ADDENDUM NO. 1

2003 / KVCC WHITNEY RESTROOM RENOVATIONS

Lewis + Malm Architecture

12MAR2021

2 MEN'S M-121B
R4 SCALE 1/2" = 1'-0"

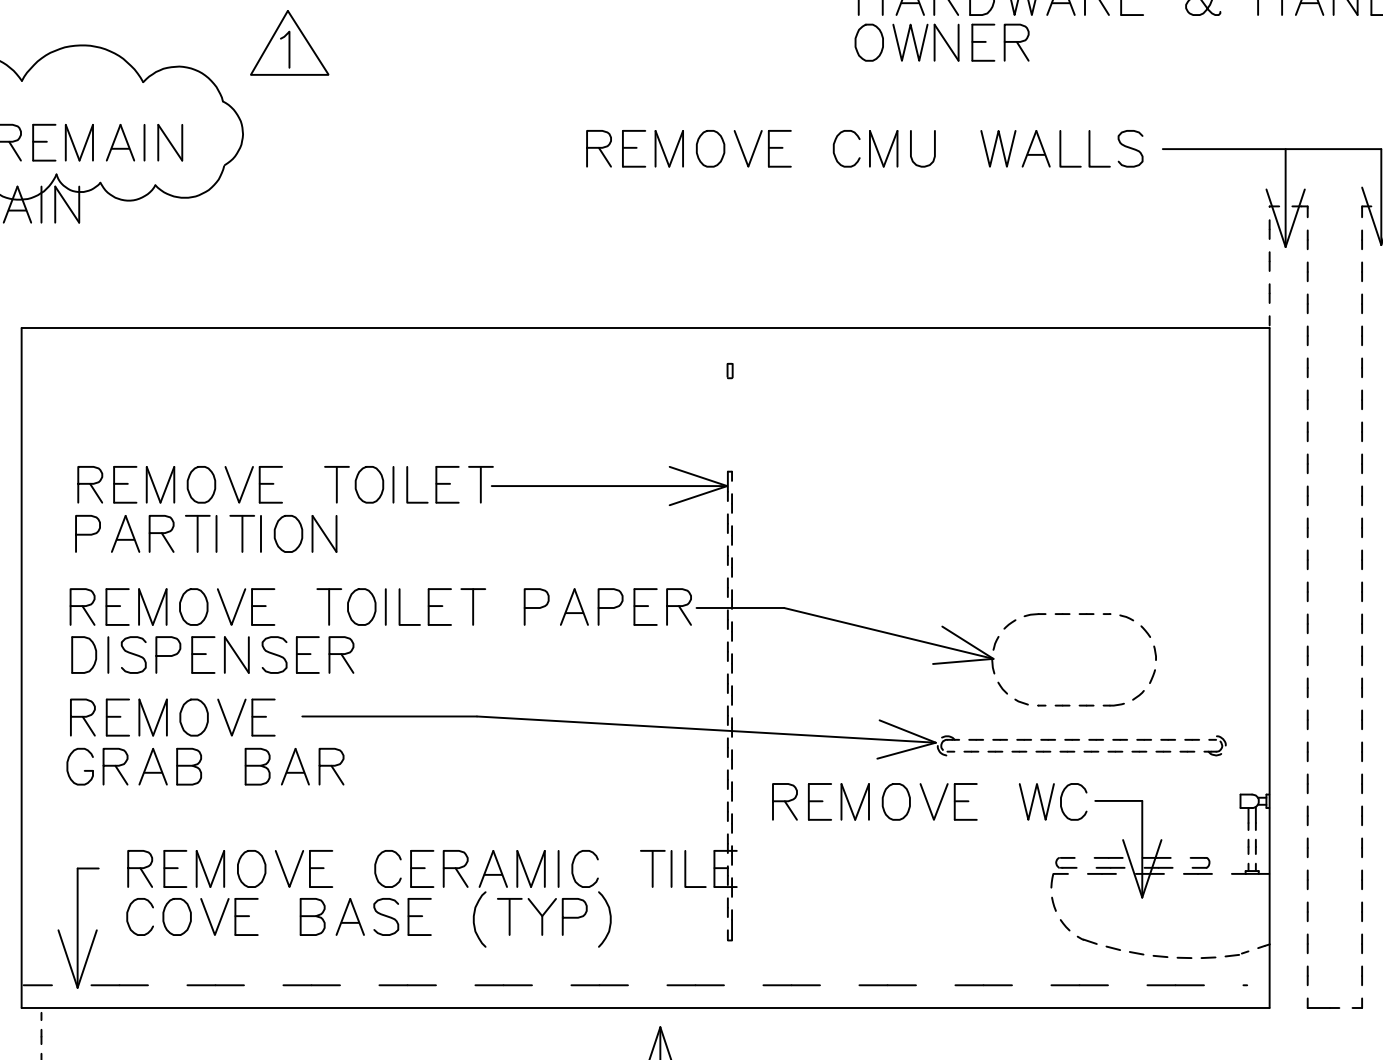
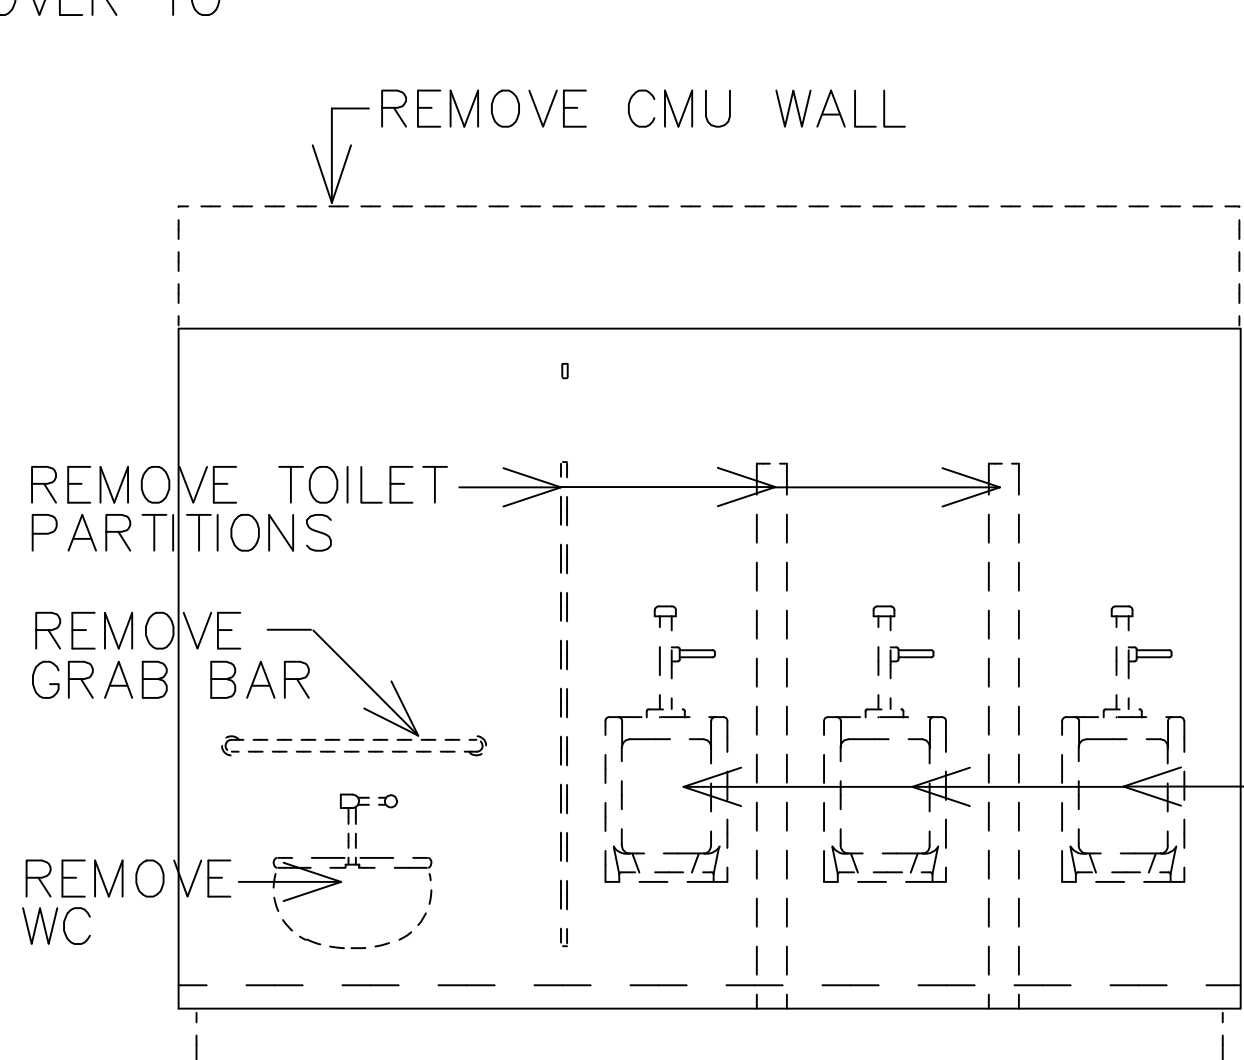
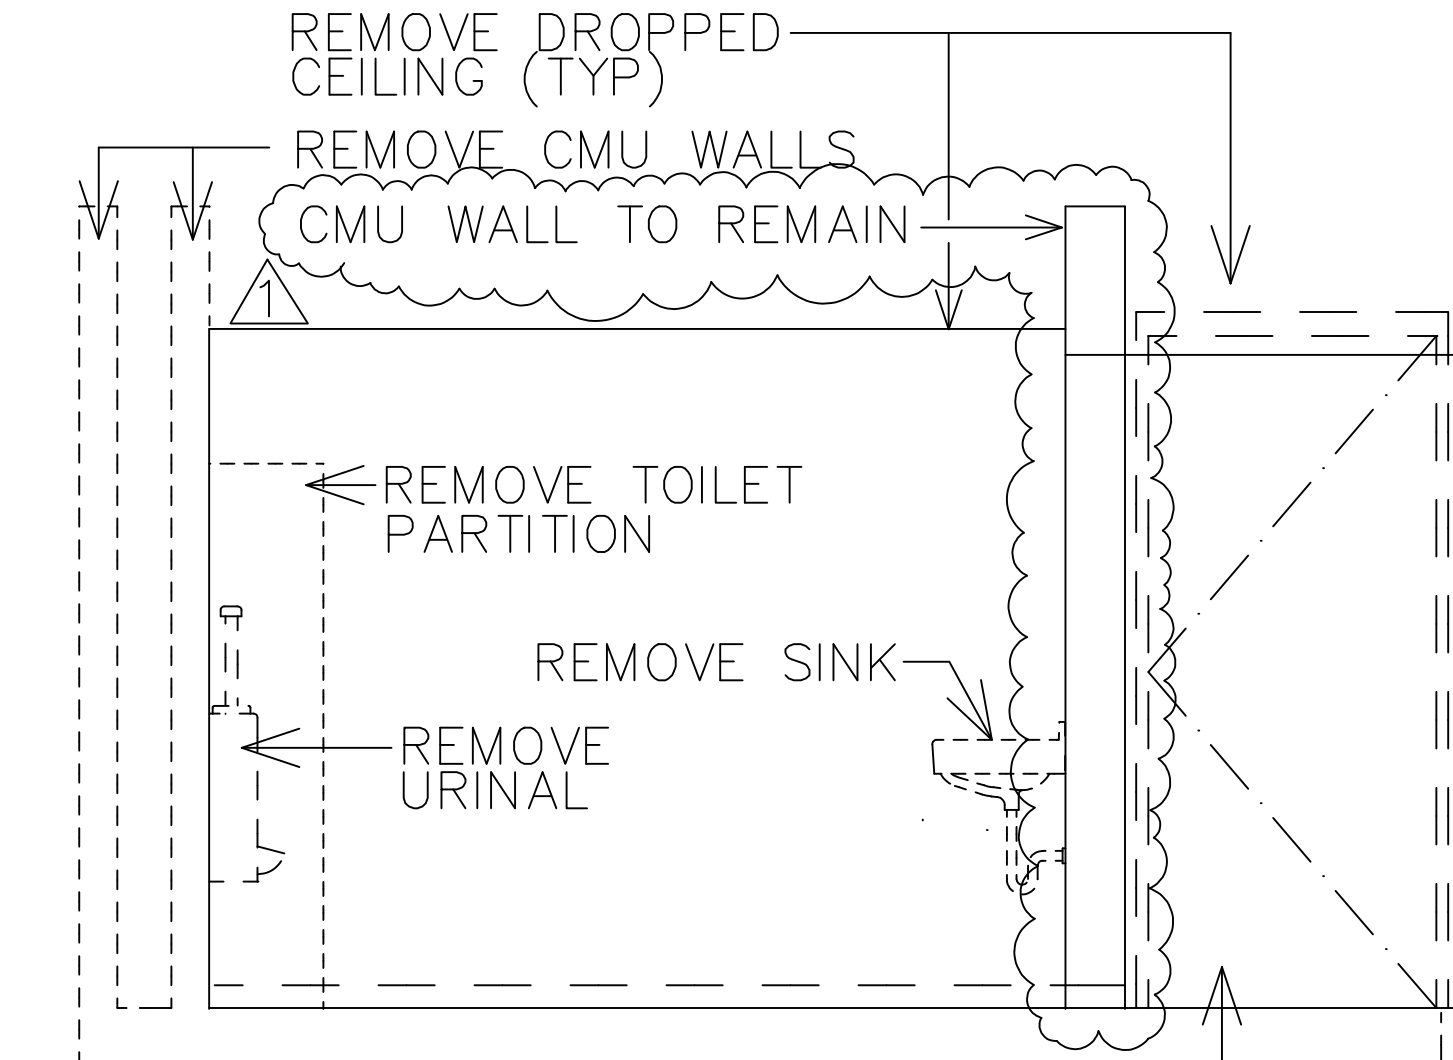
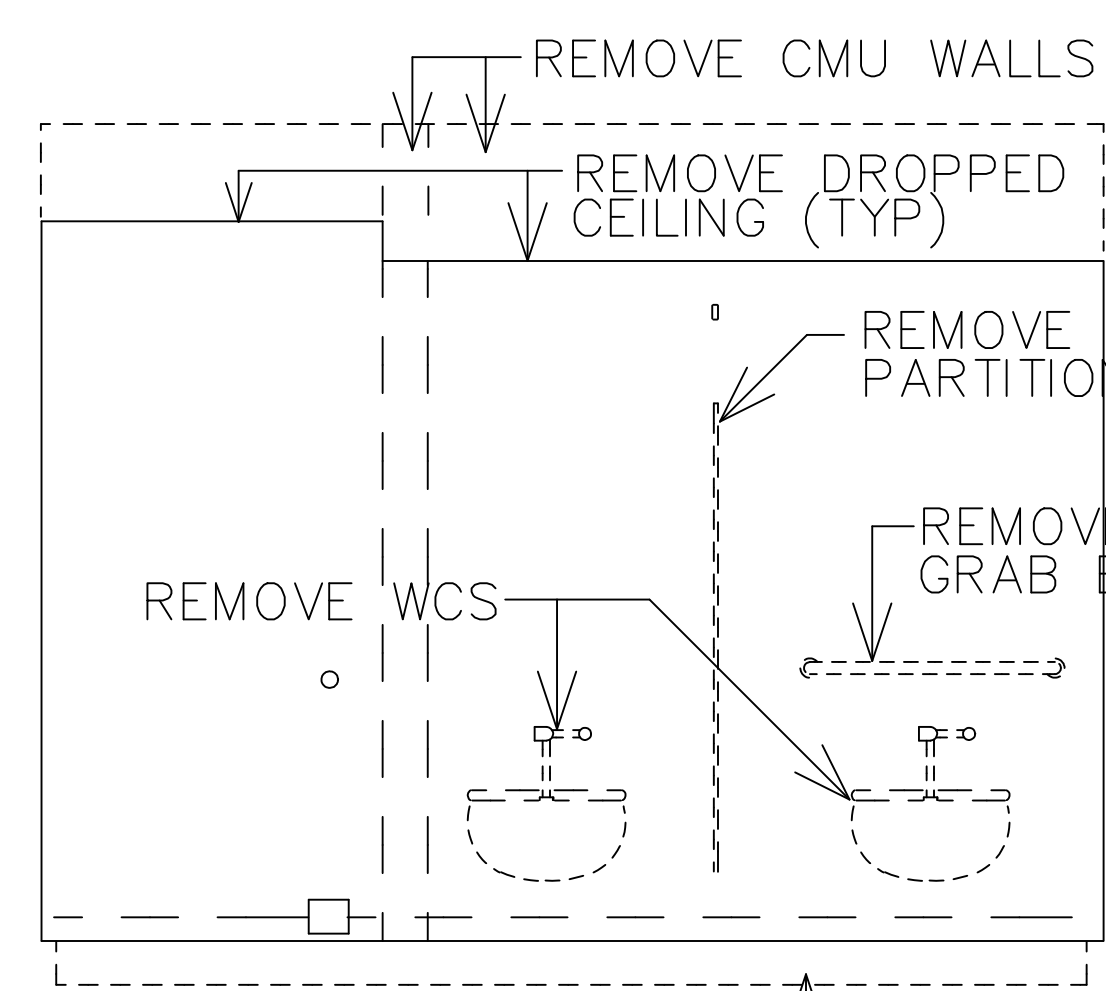
- R4 DETAIL 2 WEST** One of the existing CMU walls in Room M-121B indicated in the original bid documents to be removed is incorrectly marked, this CMU wall shall remain in the project as indicated on A1 Detail 2 and A3 Details 2 North & West. See attached Revision 1 Drawing R4 dated 11MAR2021.
- A10 / DETAIL 1** ADD NOTE READING "Perform waterproof test after installation", at the new pre-fabricated rooftop curb for EF-2 (refer to DWG H2).

CMU WALL TO REMAIN
ALARM TO REMAIN

REMOVE DROPPED CEILING (TYP)
REMOVE CMU WALLS
CMU WALL TO REMAIN
